RS-15-255

R. E. Ginna Nuclear Power Plant  
Renewed Facility Operating License No. DPR-18  
NRC Docket No. 50-244

Subject: Response to NRC Audit Review Request for Additional Information Regarding  
Fukushima Lessons Learned - Flood Hazard Reevaluation Report

**Response to NRC Audit Review Request for Additional Information Regarding  
Fukushima Lessons Learned - Flood Hazard Reevaluation Report**

**Figure 9-1: LIP Time Series Plot for Grid Element 6193 – East of Reactor Containment**

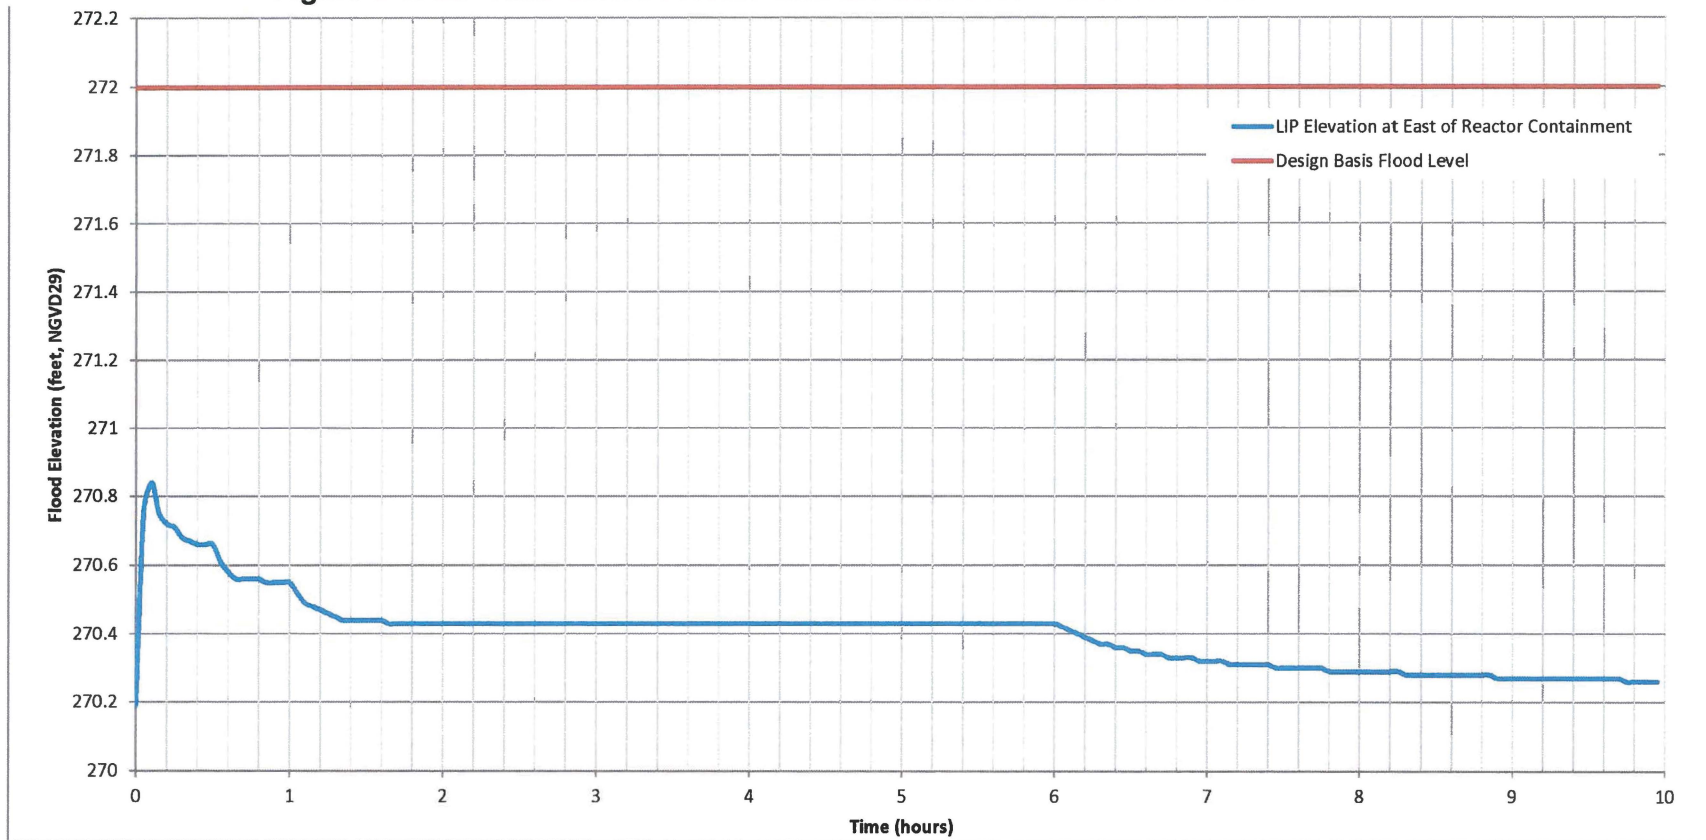
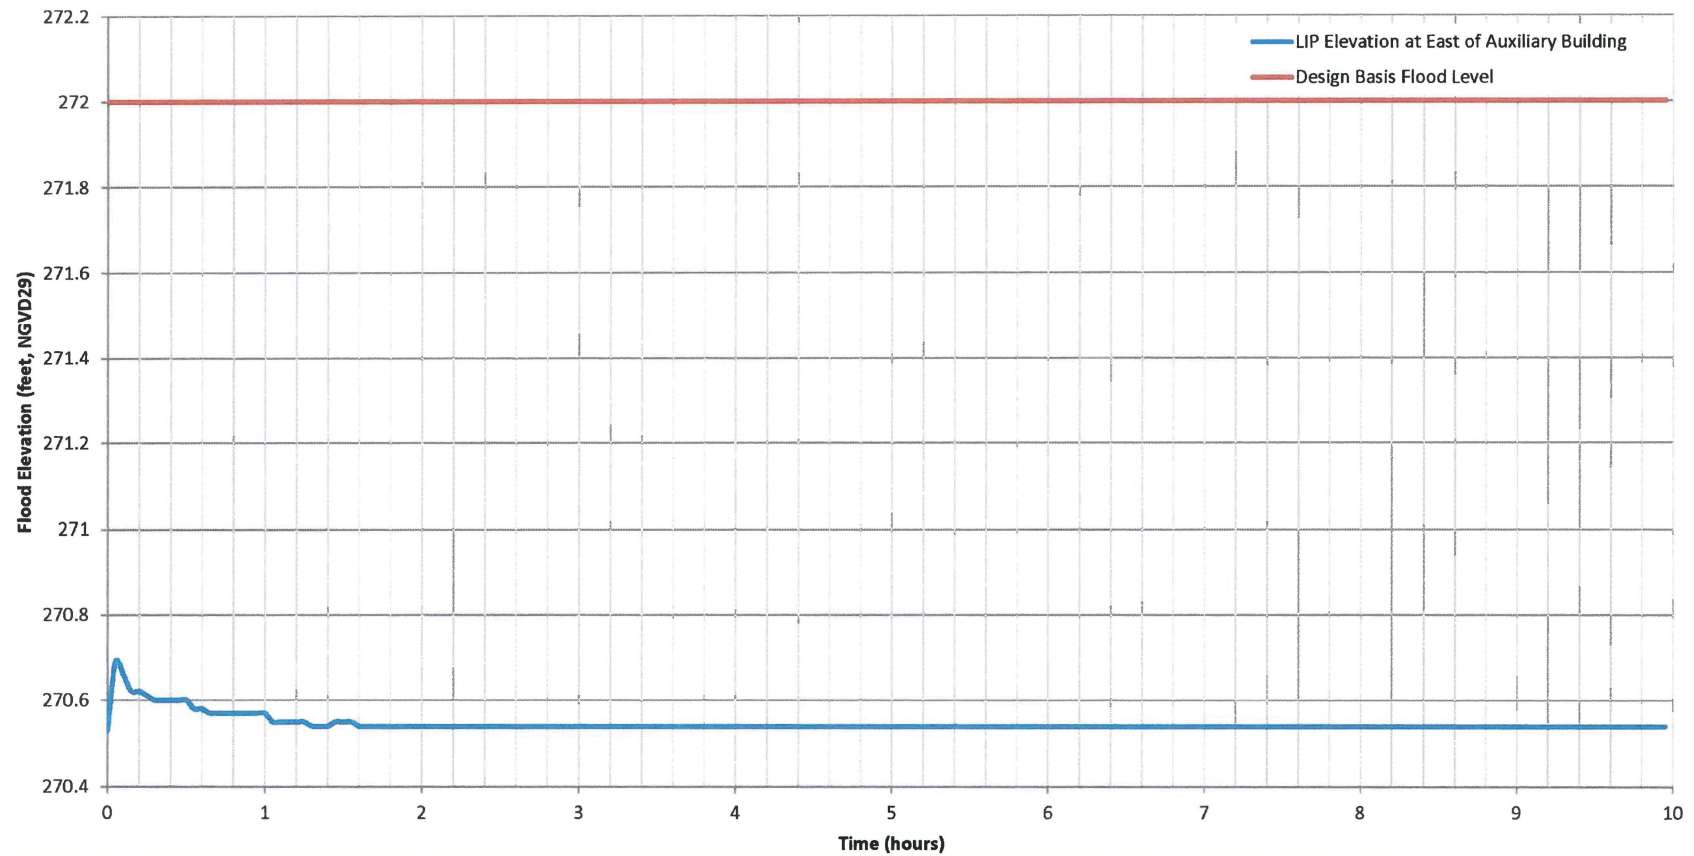
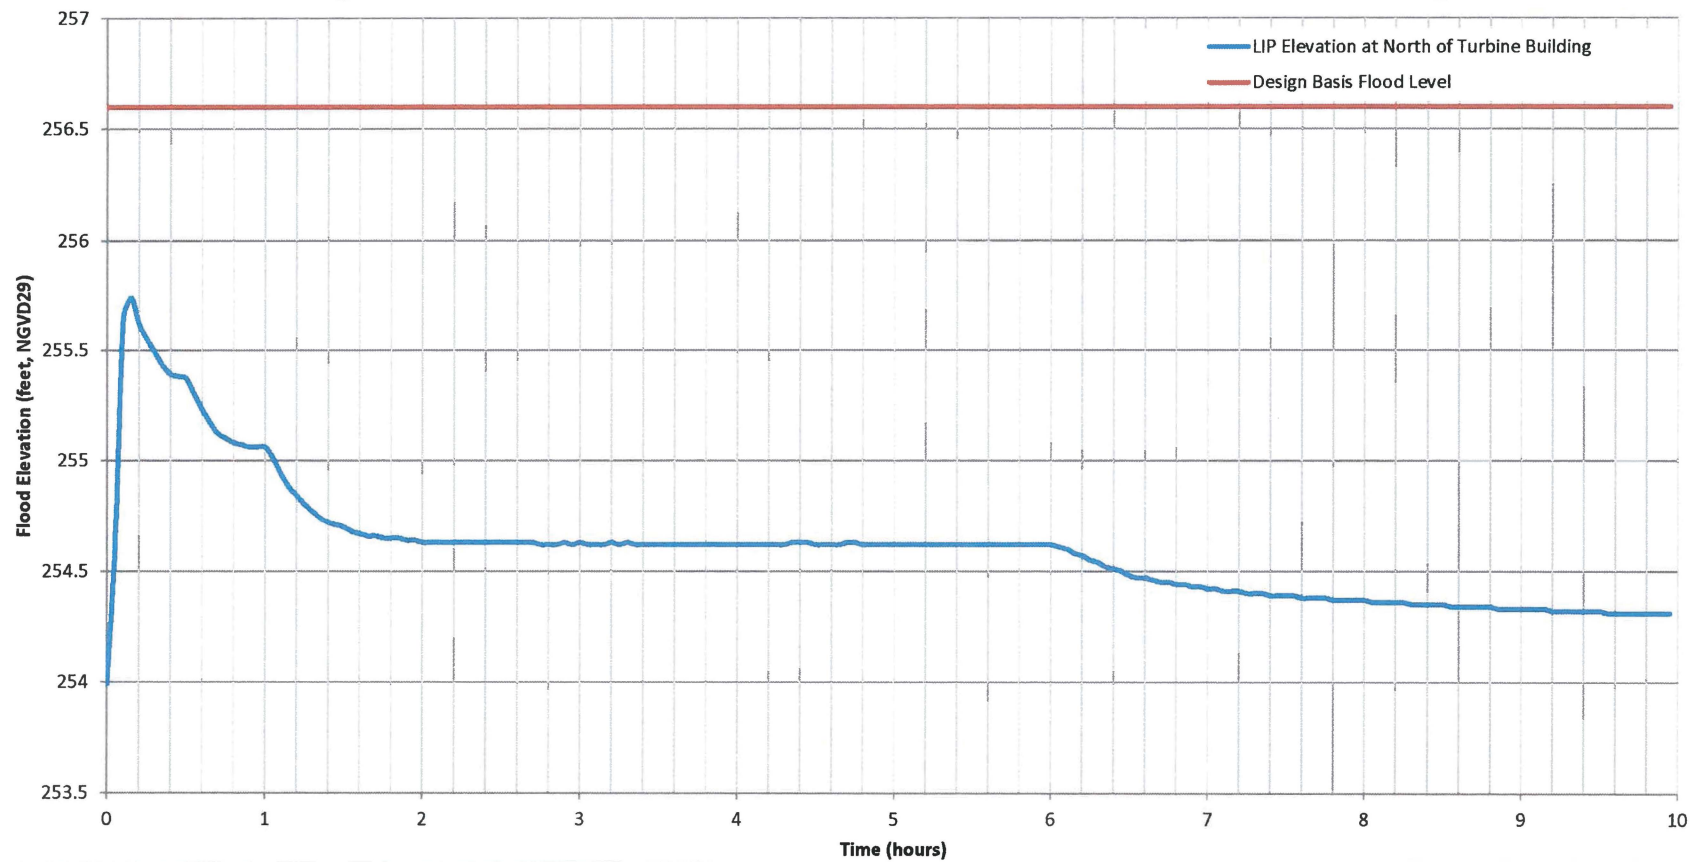
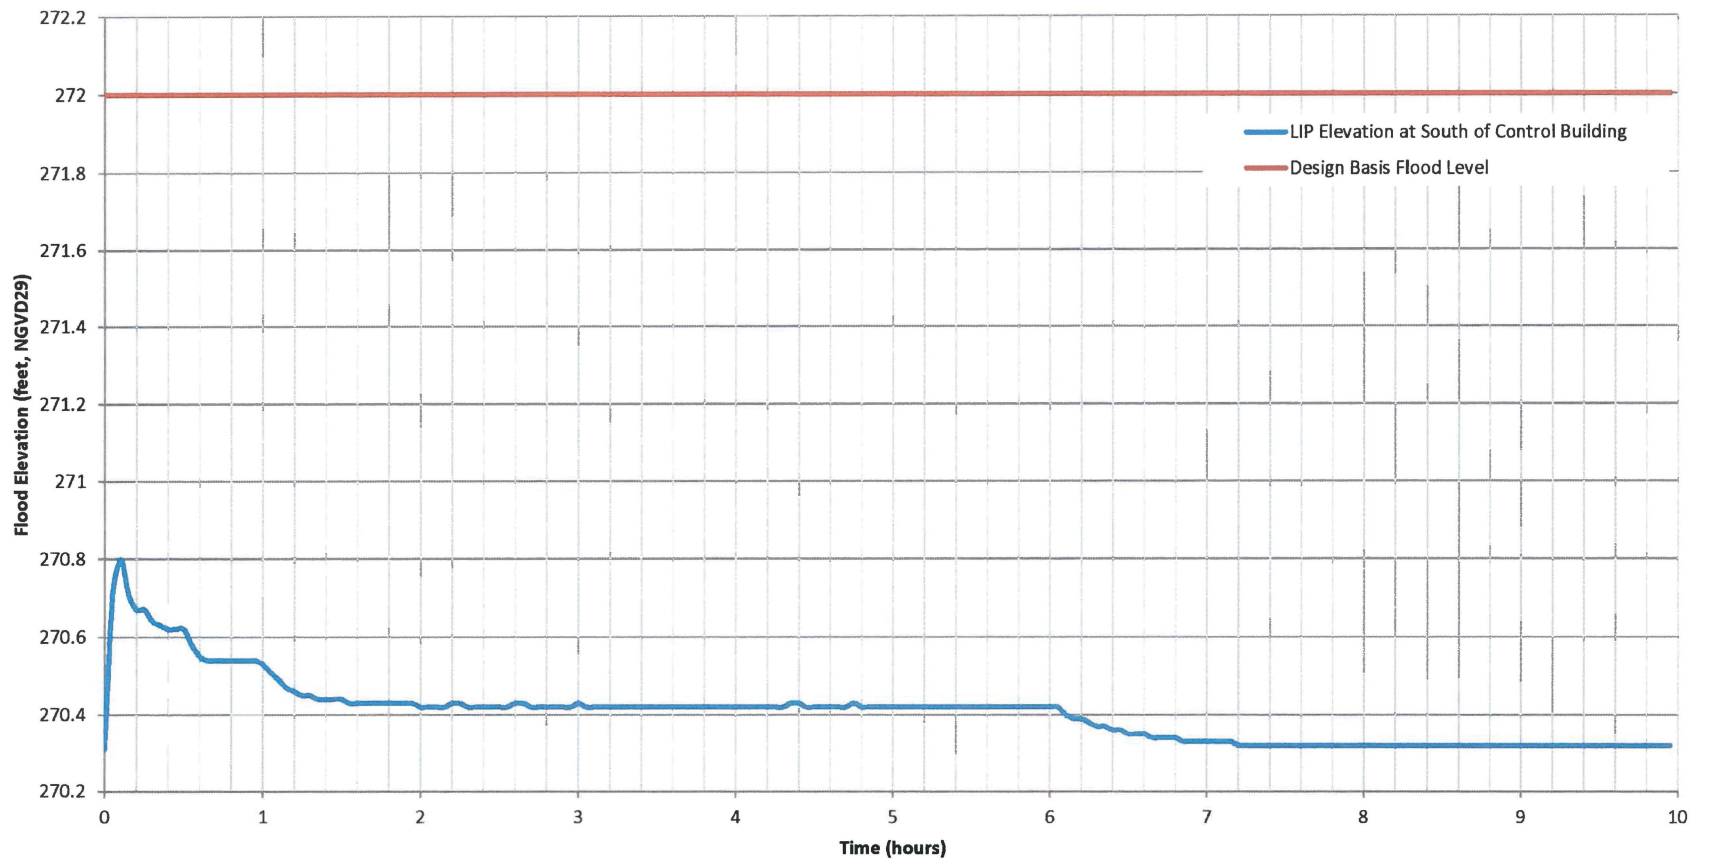
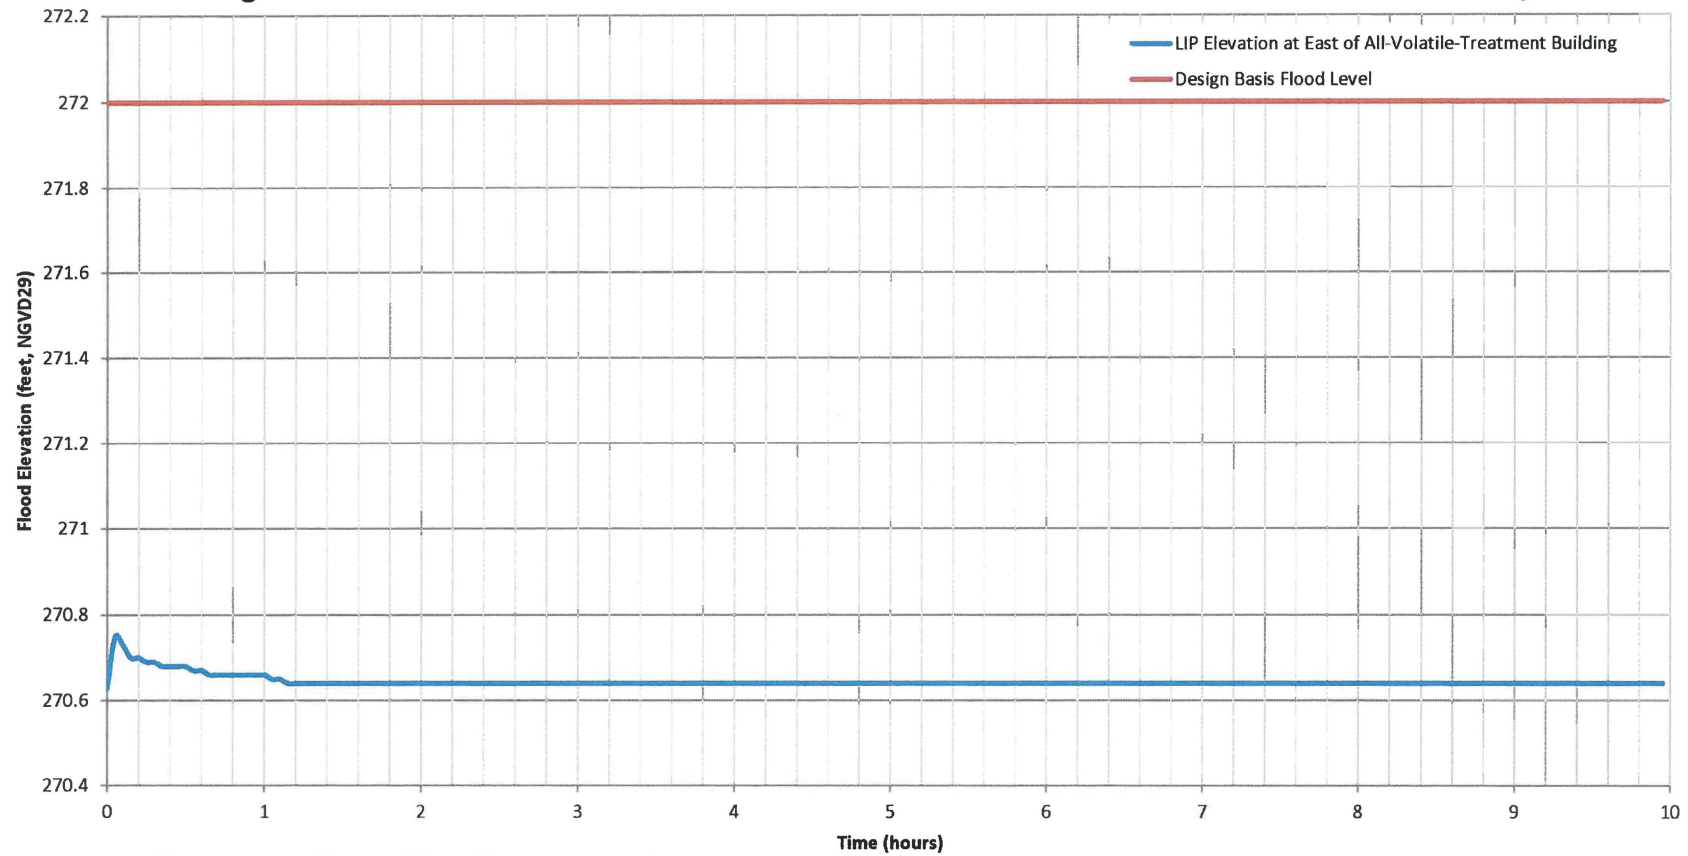
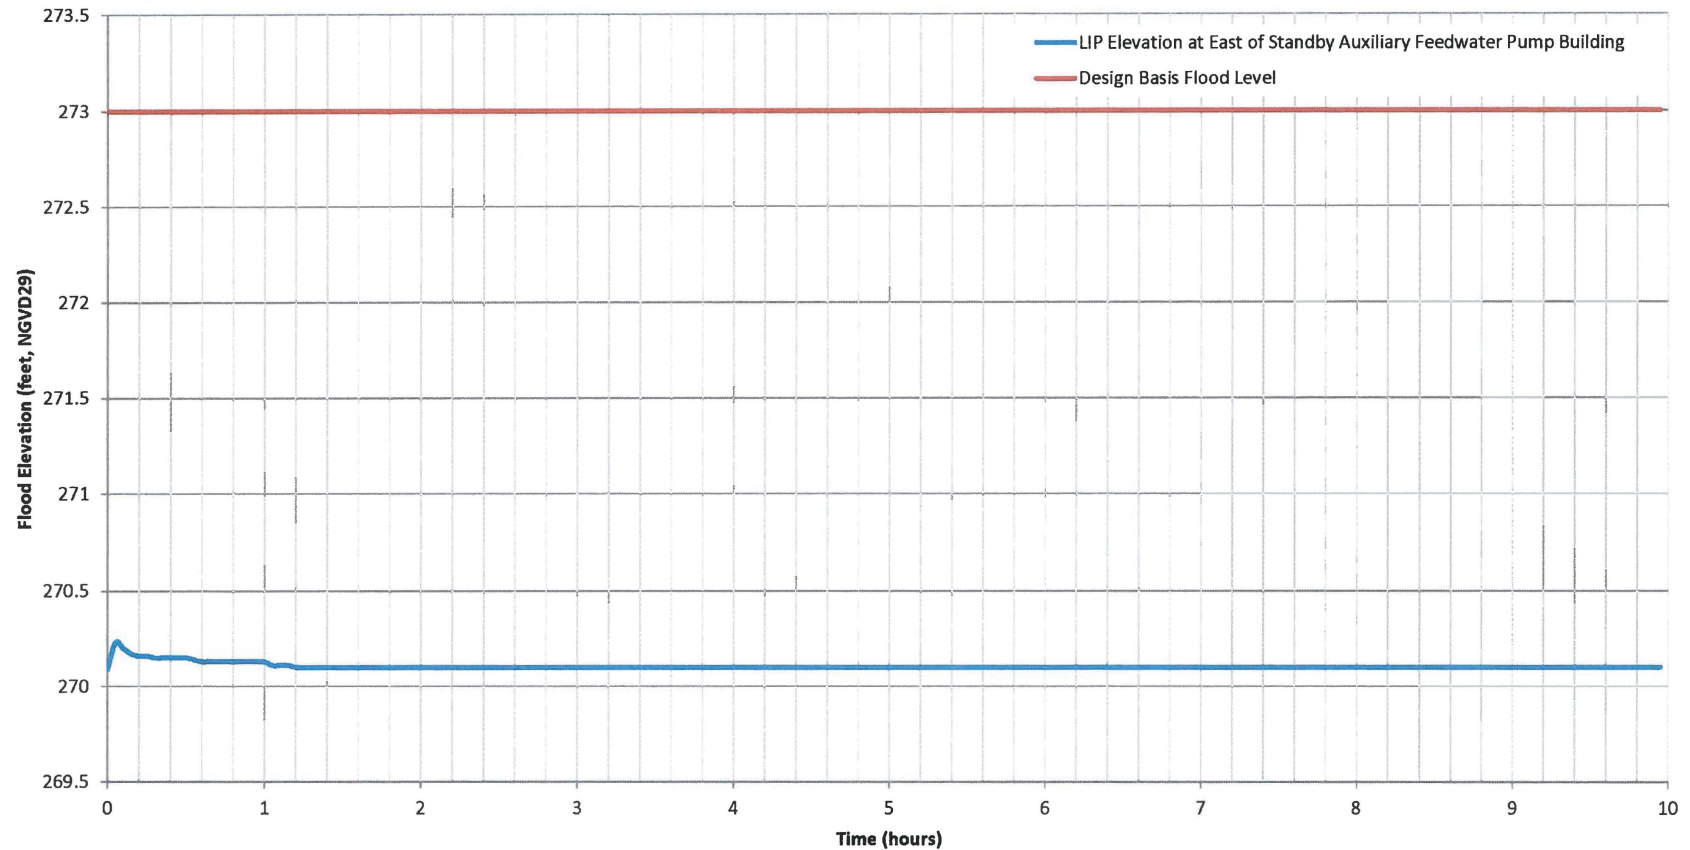
**Request:** *Provide the applicable flood event duration parameters (see definition and Figure 6 of the Guidance for Performing an Integrated Assessment, JLD-ISG-2012-05) associated with mechanisms that trigger an Integrated Assessment using the results of the flood hazard reevaluation. This includes (as applicable) the warning time the site will have to prepare for the event (e.g., the time between notification of an impending flood event and arrival of floodwaters on site) and the period of time the site is inundated for the mechanisms that are not bounded by the current design basis. Provide the basis or source of information for the flood event duration, which may include a description of relevant forecasting methods (e.g., products from local, regional, or national weather forecasting centers) and/or timing information derived from the hazard analysis. The FHRR does state a PMF flood duration (6.5 h) but other parameters are lacking.*

*In Section 3.3 of the FHRR, LIP, flooding on rivers and streams, and two combined-effects flood scenarios were stated to exceed the current licensing basis (which needs to be evaluated/corrected per Information Need #1). The FHRR did not provide sufficiently clear information on all flood duration parameters.*

Time series graphs for the LIP flood mechanism at key locations are provided as Figures 9-1 through 9-9. Time series graphs for the combined effect PMF flood mechanism at key locations are provided as Figures 9-10 through 9-19.

The FHRR indicates flood protection measures described in the FSAR trigger on flood levels at Driveway Bridge. Based on detailed time-series data for the combined effect flood scenario (bounding Deer Creek flooding scenario), there is a 35+ hour delay between the triggering flood levels at Driveway Bridge and flood levels above grade near plant structures.
